City of San Antonio

Agenda Memorandum

Case Number: BOA-19-10300084
Applicant: Joe Salinas
Owner: Brenda and Meade Vance
Council District: 1
Location: 225 E. Mistletoe Ave
Legal: The South 80 feet of the East 25 feet of Lot 13 & the South
Description: 80 feet of Lot 14, Block 1, NCB 853
Zoning: "R6 AHOD" Residential Single-Family Airport Hazard
Overlay District
Case Manager: Crystal Gonzales, Development Services Engineer; Debora Gonzalez, Senior Planner

A request for an appeal of the Director's decision related to issuance of a building permit for an accessory structure with accessory detached dwelling unit; UDC Section 35-310.01(b). Generally, UDC Section 35-A101: Definitions and Rules of Interpretation, and UDC Section 35-371(b)(6): Accessory Detached Dwelling.

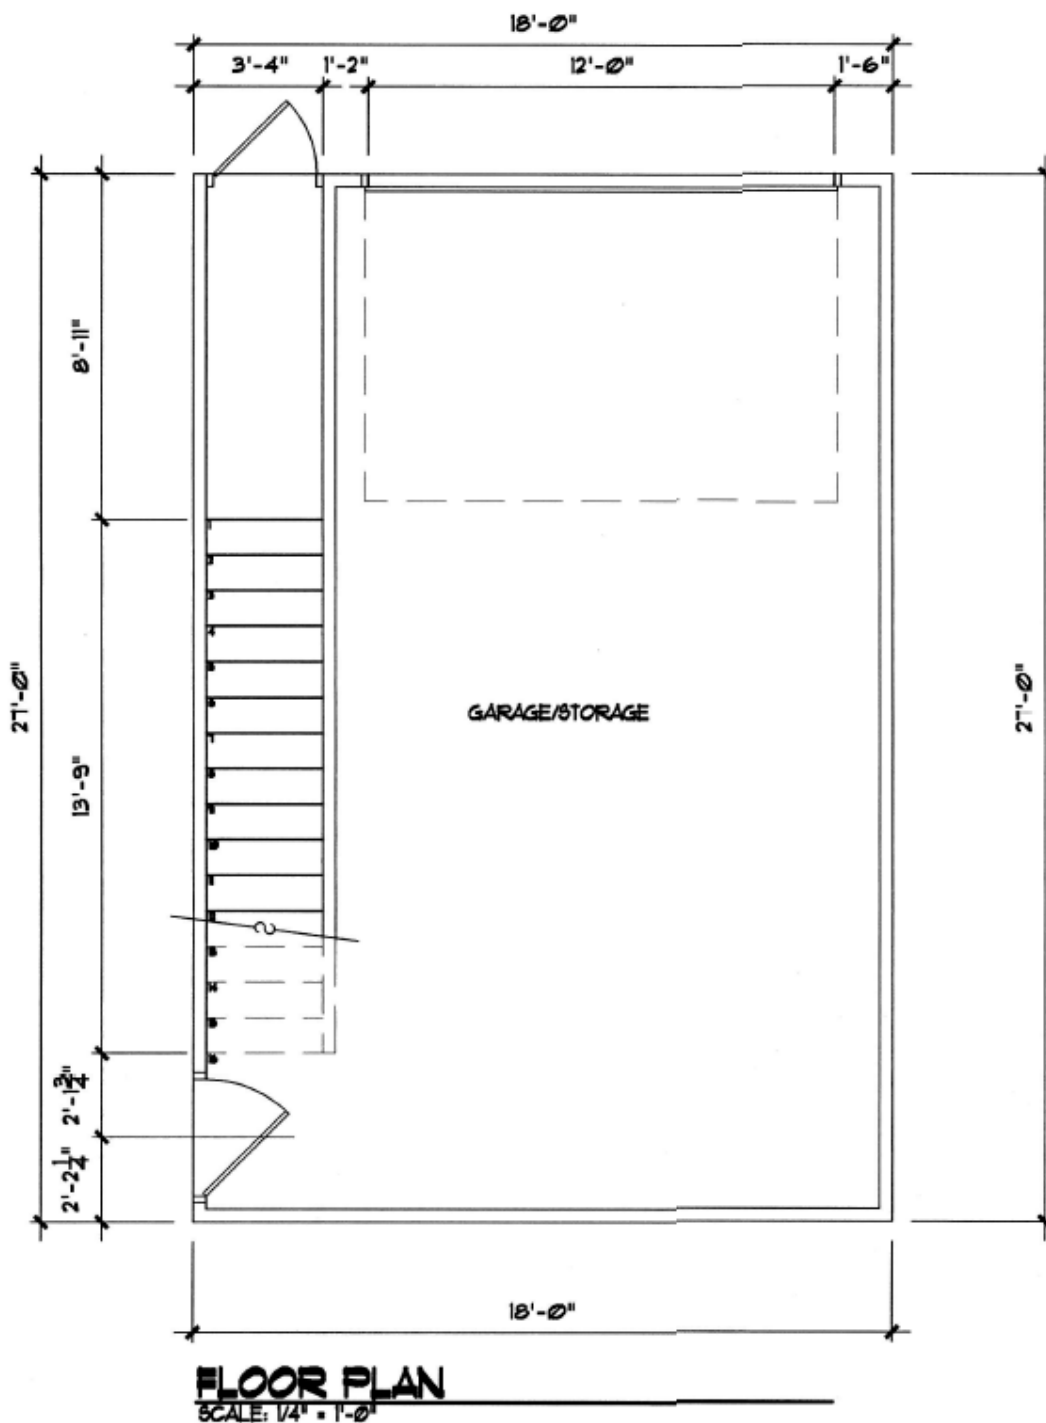
The applicant references this section of code to identify the restrictions on the height, in maximum feet, and the maximum number of stories for a property zoned R-6.

The maximum height of a structure for a property zoned R-6 is 35 feet and 2 ½ stories per Table 310-1.

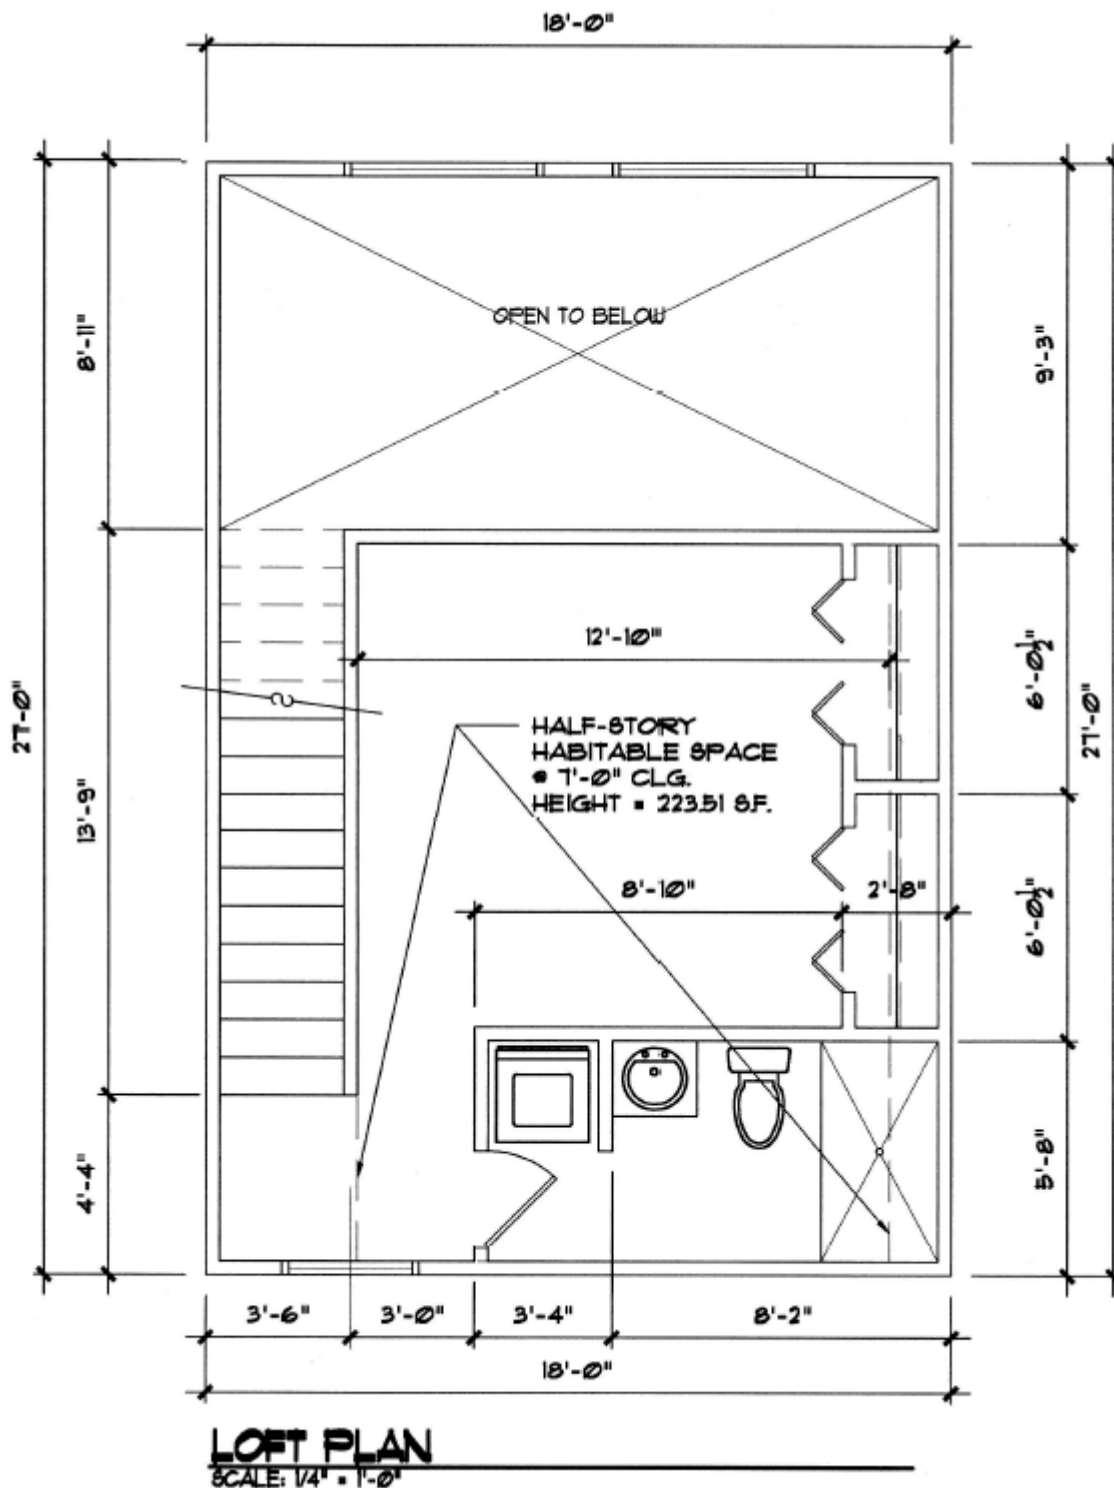
Per the definition of half story, the habitable areas on the uppermost story shall not exceed a floor area derived by multiplying the floor area of the ground floor by fifty (50) percent.

First, the area of the ground floor must be determined from the building plans.

The area of the ground floor is calculated by multiplying 18 feet by 27 feet to obtain a floor area of 486 square feet. Fifty percent of the ground floor area is 243 square feet. The habitable area on the uppermost story cannot exceed a floor area of 243 sf.

The codes clearly recognize that habitable area and floor area are not one in the same. To calculate the habitable area of the uppermost floor, the area of the bathroom, toilet room, closet, hall and storage/utility spaces are excluded from the floor area.

The habitable area of the uppermost floor calculates to be $486\text{sf} - 166.5\text{sf} - 48.13\text{sf} - 32.2\text{sf} - 65.17\text{sf} = 173.98\text{sf}$ which is well under the allowable floor area of 243sf.

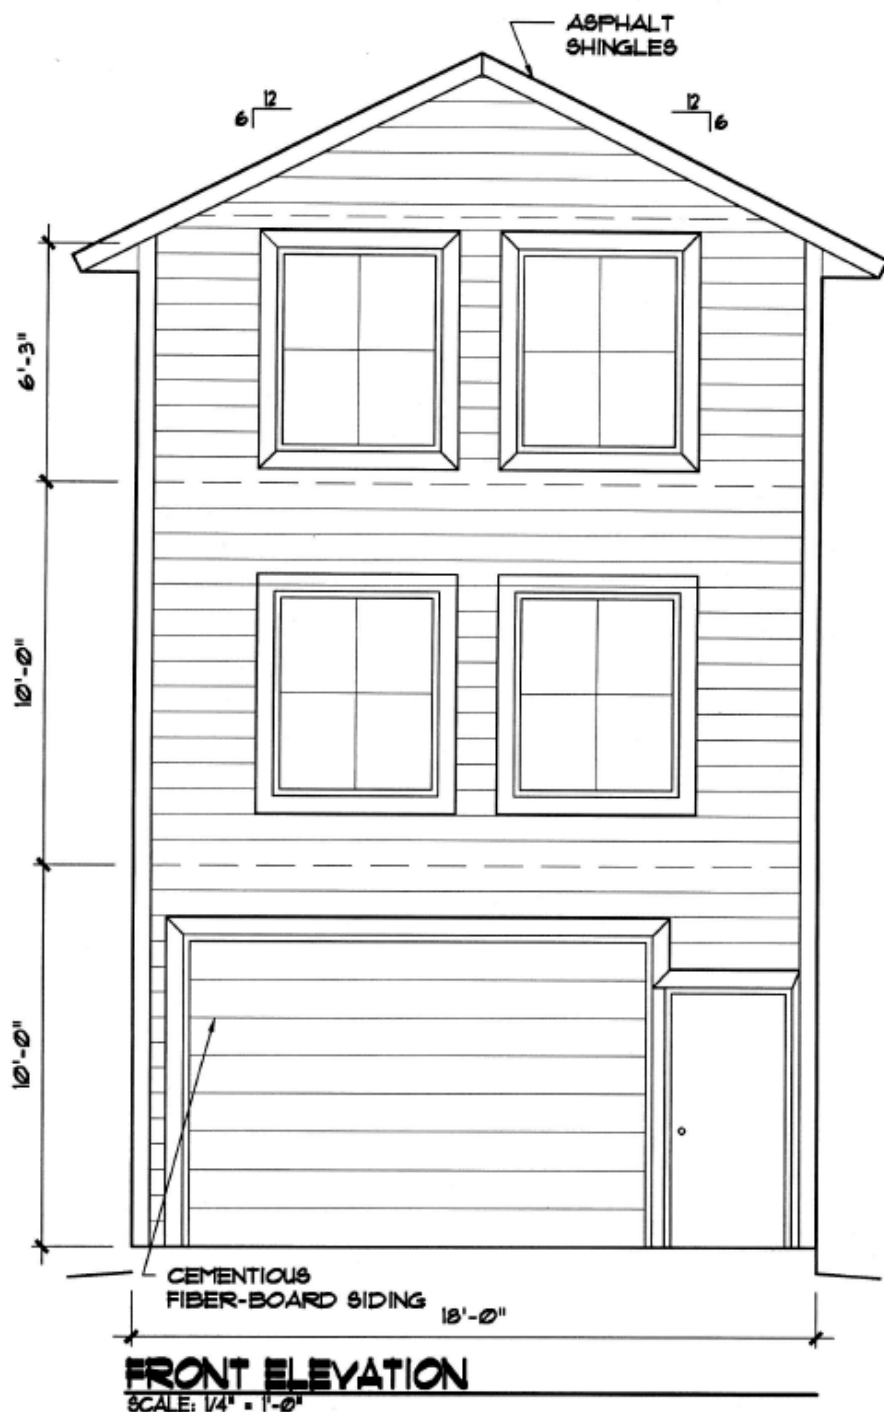
The UDC definition of height, again, states that the height shall be measured from the average elevation of the finished lot grade at the front of the building to the average height between the plate and ridge of a gable roof, in this case. The average height between the plate and ridge of the gable roof is determined by taking the total height and dividing by two. The measurement of 5ft between the plate and the top of the ridge was taken from

the plans. $5'2" = 2'6"$.

Total Height = $10' + 10' + 6'3" + 2'6" = 28'9"$ which is well under the maximum allowable 35' height. Even if the total height was measured to the top of the ridge, the height would be 31'3" and would still not exceed the maximum allowable height of 35ft.
